**TENDER 16-20**  
**WATER TREATMENT BUILDING**

**ADDENDUM NO. 6**

**October 12<sup>th</sup>, 2016**

DRAWING NO.	15-508- P102
PROJECT:	112311316
REV.	6

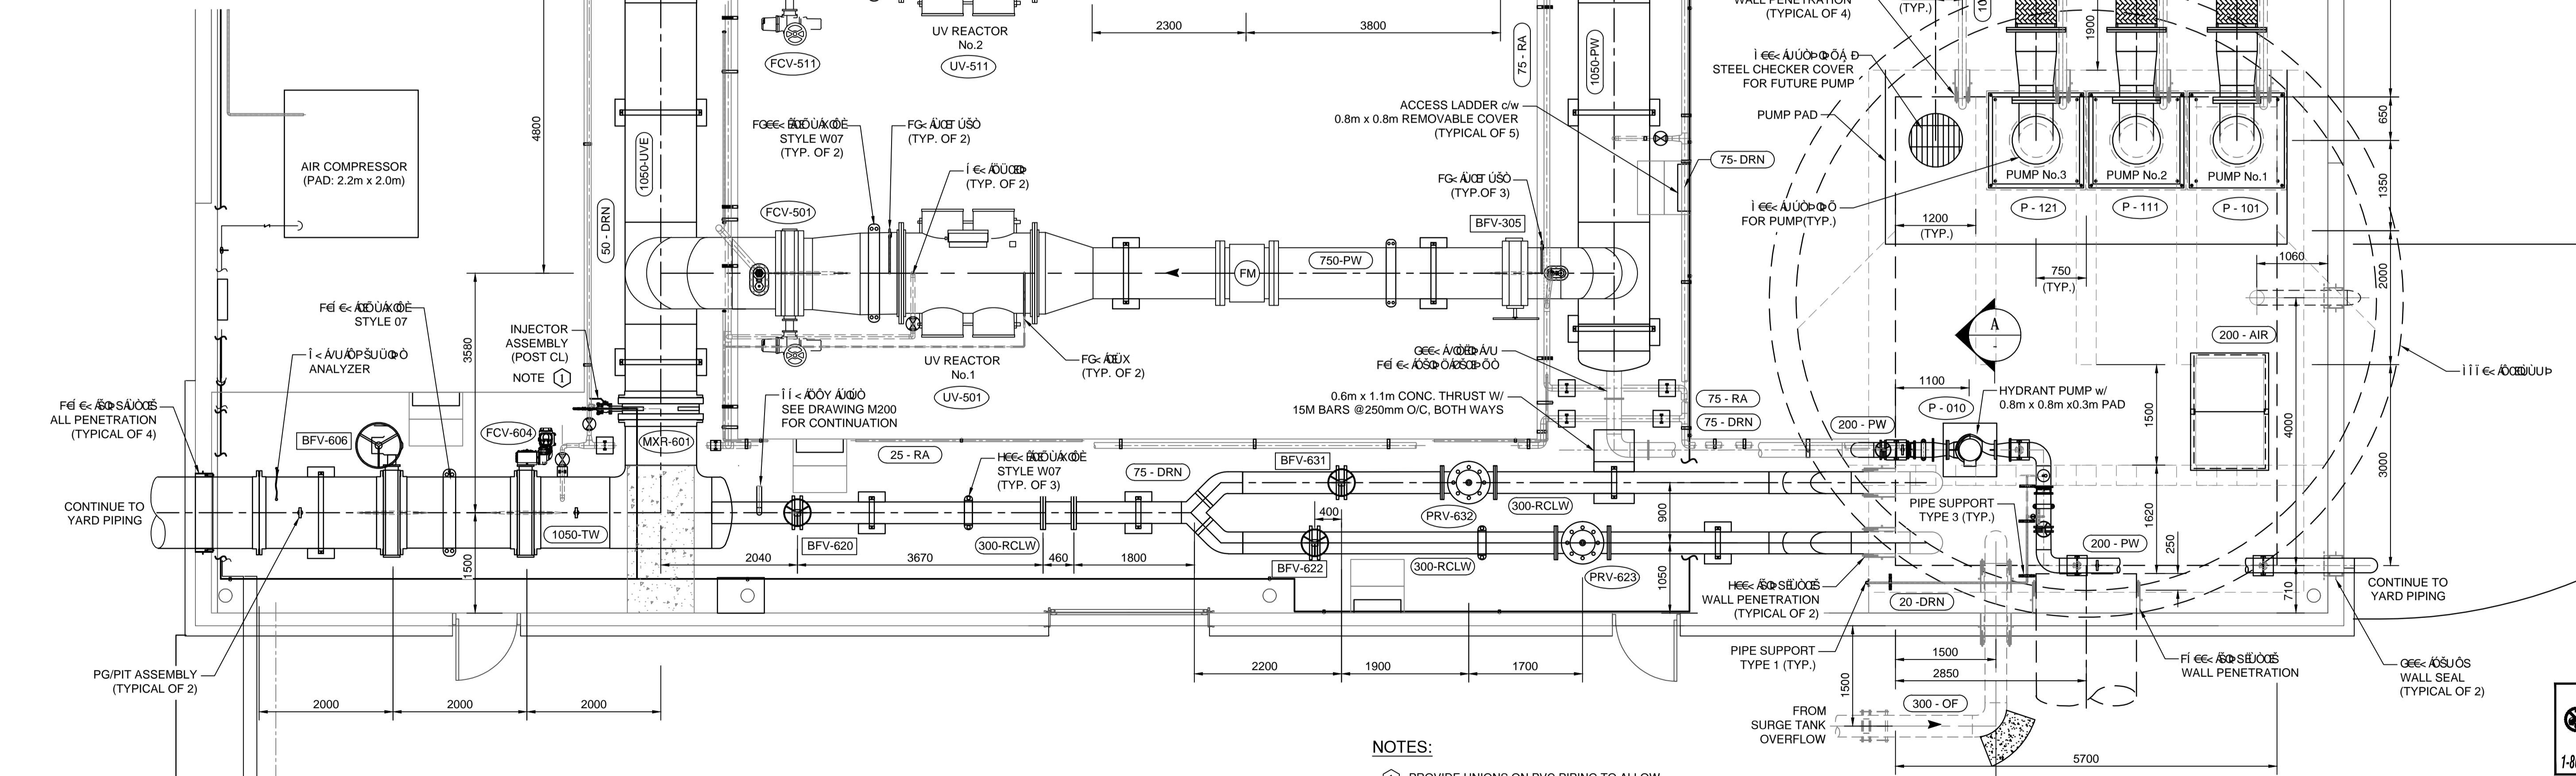
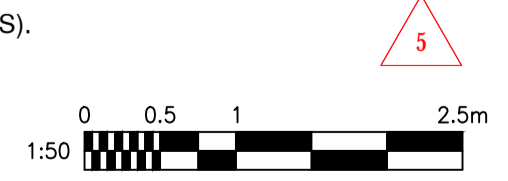
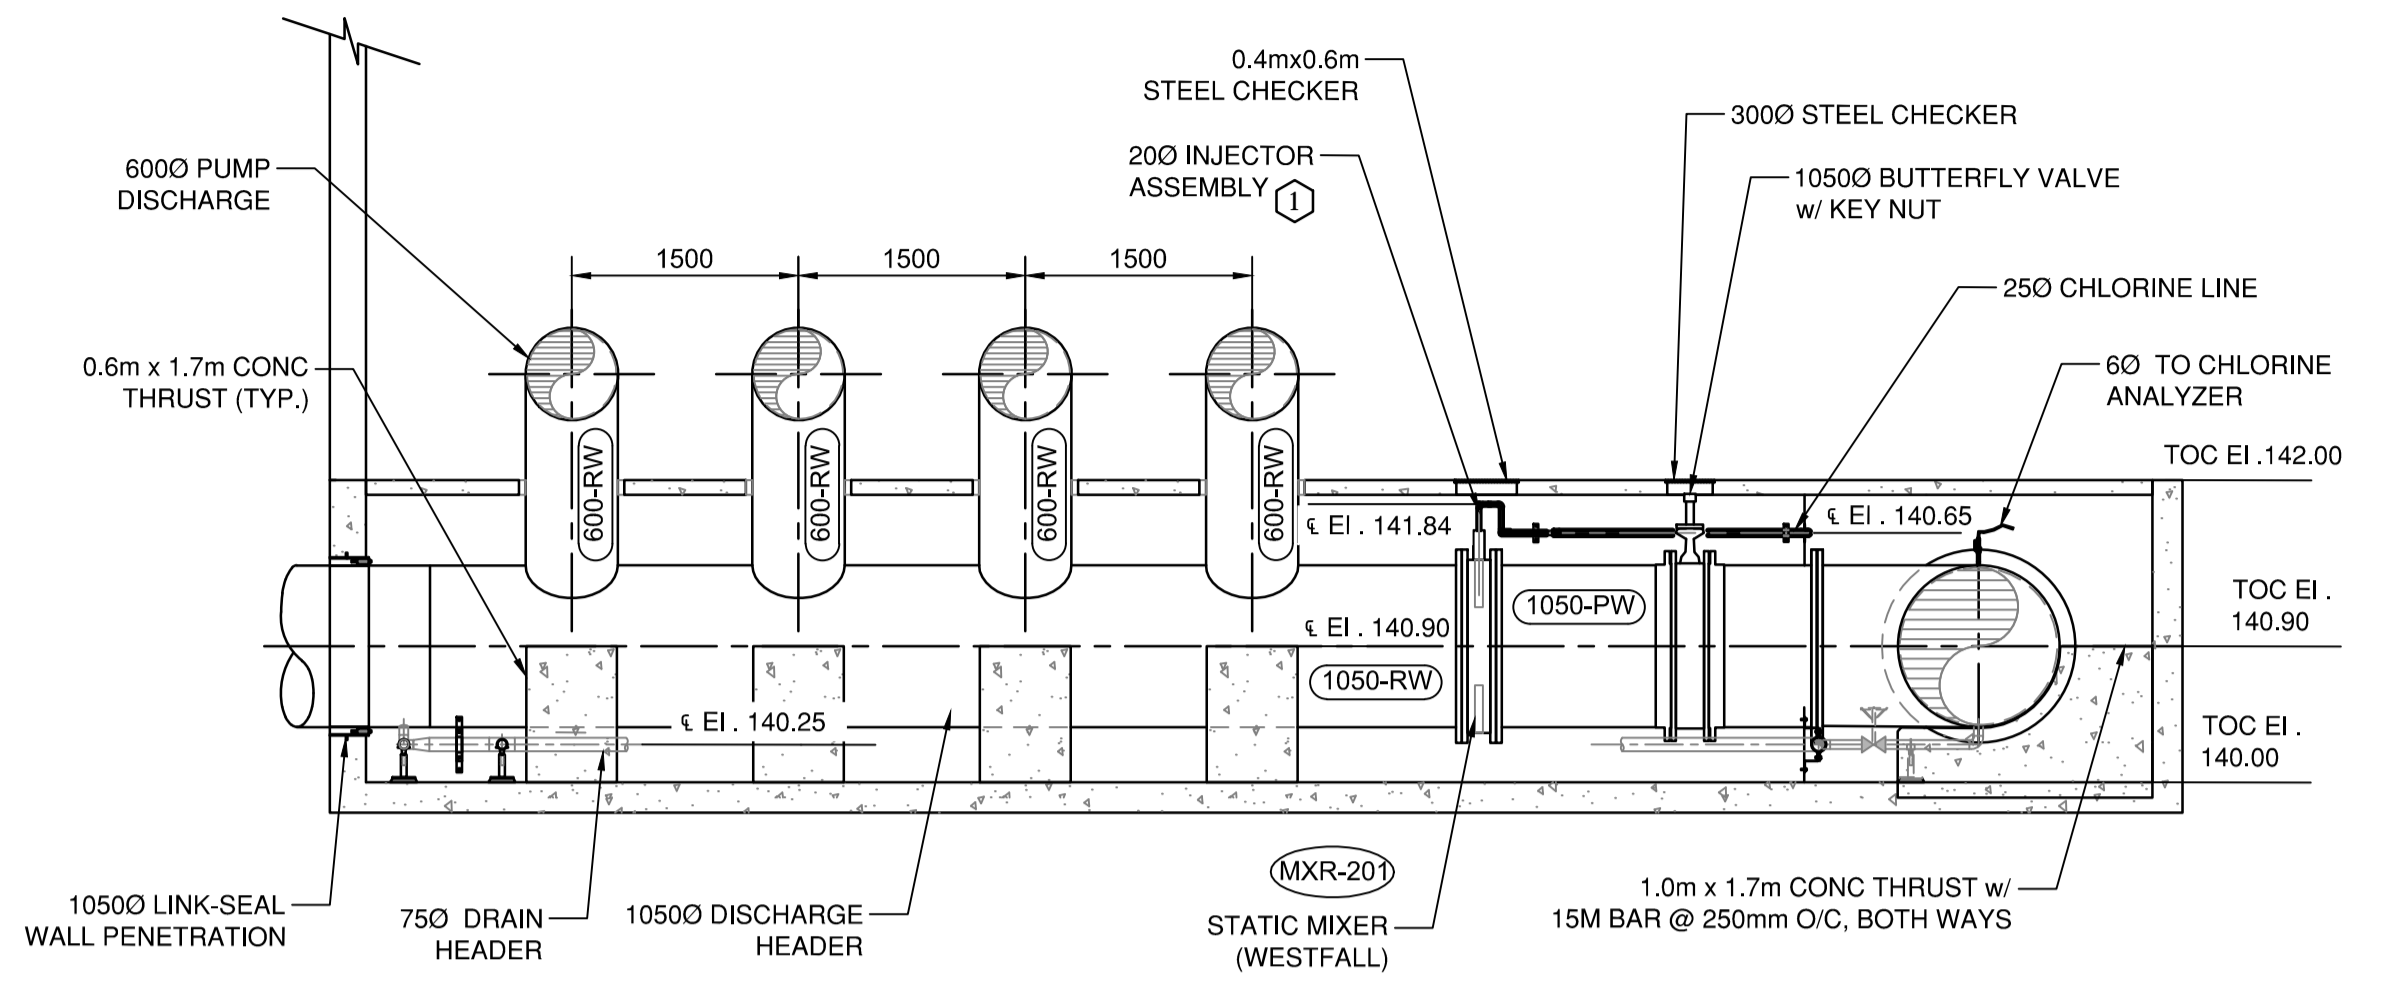
Process valve tags on drawings differ from that in section 40 06 23, do you know which is to be correct?

Updated layout drawings and spec provided.

Refer to the attached drawings and specifications that address the valve labeling discrepancy.
